## **Technical Service Information**

## FORD C-3 FRONT SEAL POP-OUT

Figure 1

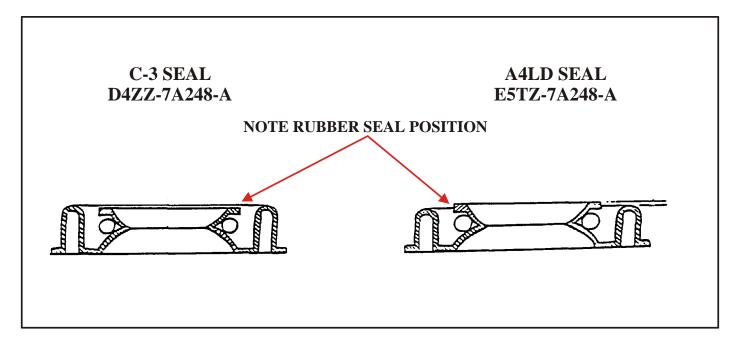
**COMPLAINT:** C-3 font seal pops out after overhaul or seal replacement.

CAUSE: One cause can be the use of a a4ld front seal Used in place of the c-3 front seal. See figure 1

(A4LD seal)note that the lip of The seal protrudes past the metal base of the Seal housing. When. The seal is installed the Rubber portion of the seal restricts the drain Passage

behind the seal. In figure 1 (C-3 seal) The seal lip is below the metal base of the seal.

**CORRECTION:** Install a C-3 front seal (D4ZZ-7AZ48A) in C-3 transmissions.
